April 13, 2015

**Subject: Century Tire Plaza – 195 Kennebec Street
Project ID# 2015-027
Review Comments Received April 8, 2015**

PRELIMINARY - NOT FOR CONSTRUCTION

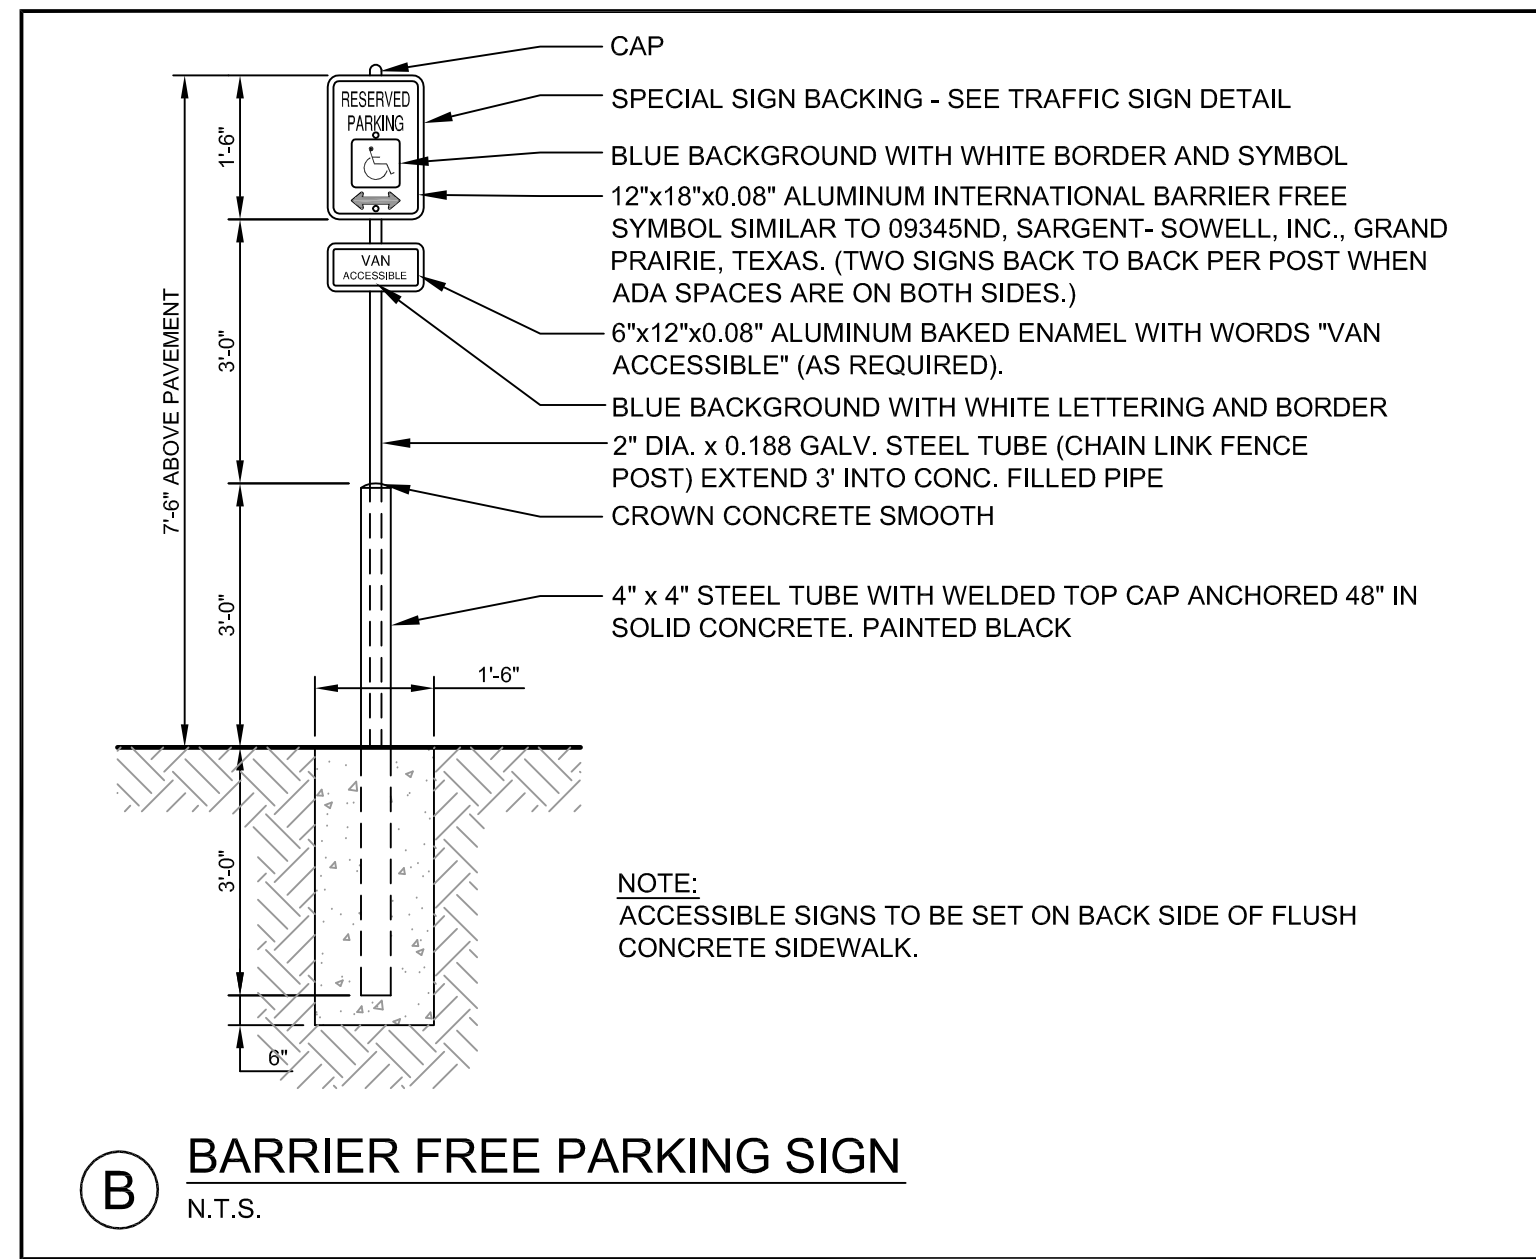
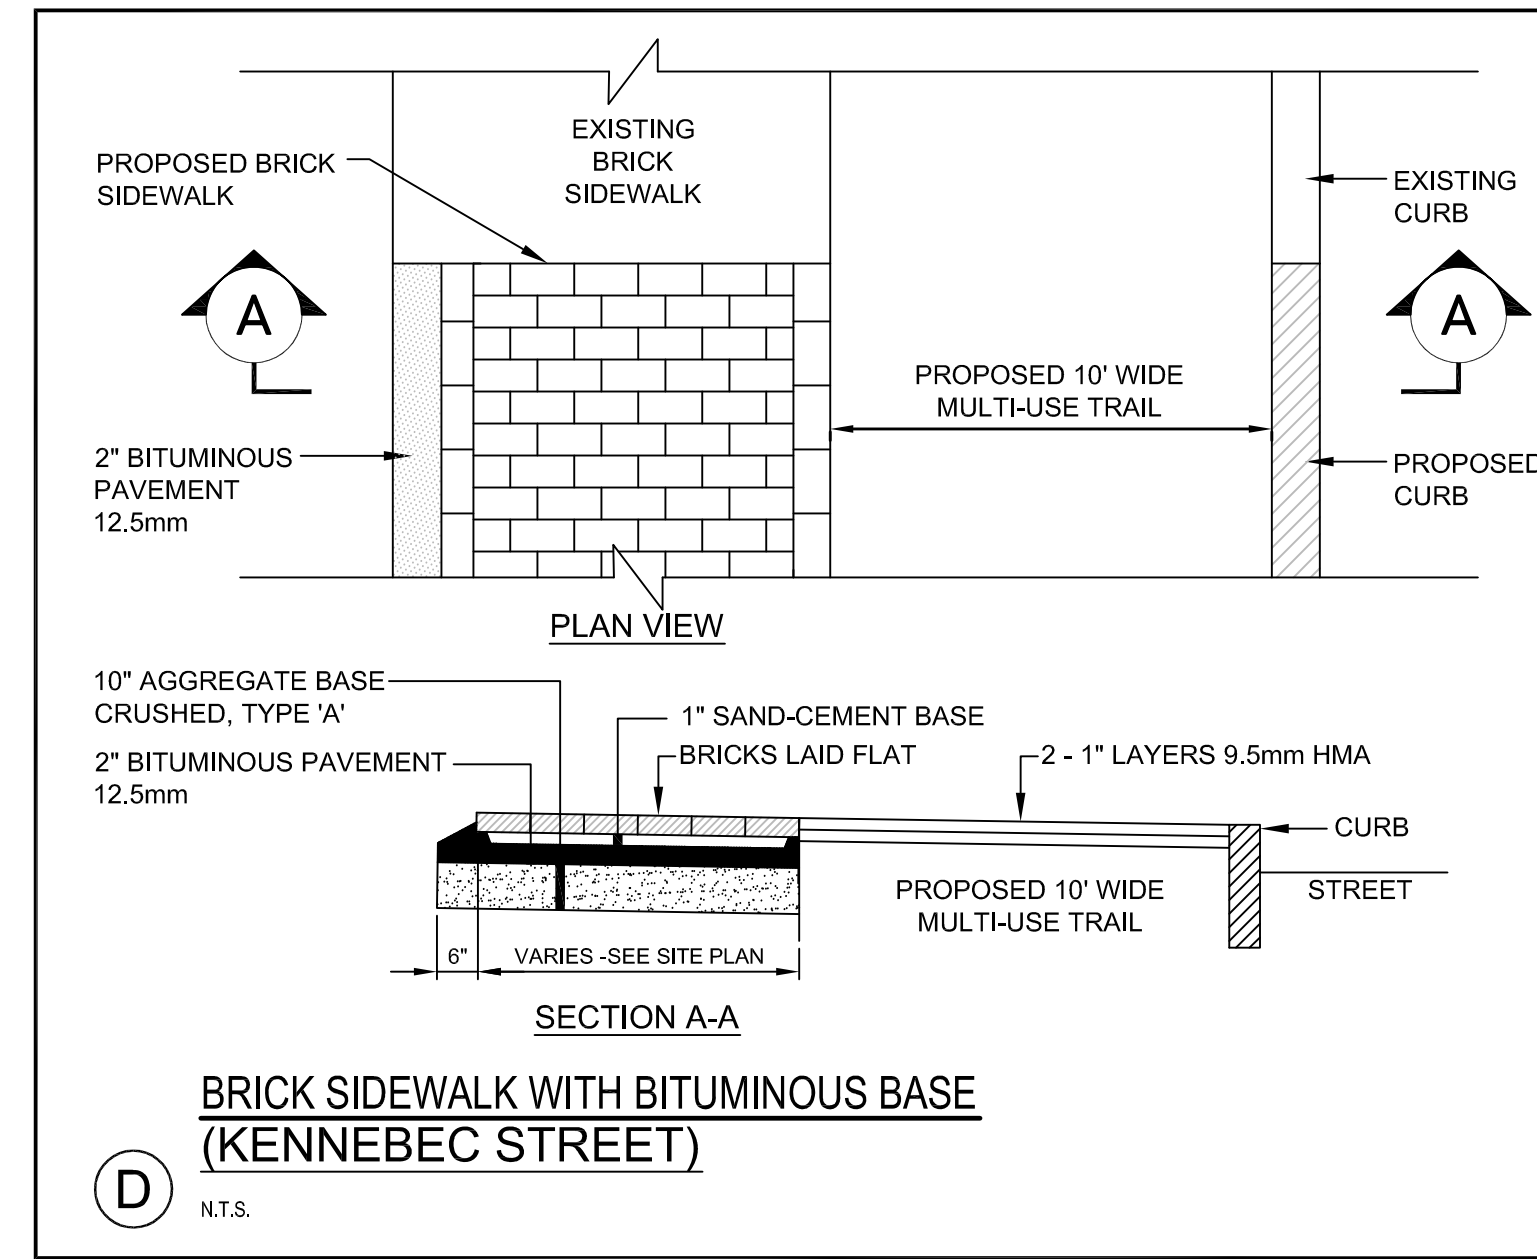
Detail C on plan sheet C-7.0, detail D on sheet C-7.2, and detail E on sheet C-7.2 all should be corrected to show the City standard for depth of base gravel for a brick sidewalk on bituminous base. The depth of gravel should be 10 inches, not 4 inches as indicated in the above referenced details.

The referenced details have been amended on the revised plan sheets to conform to City Standards.
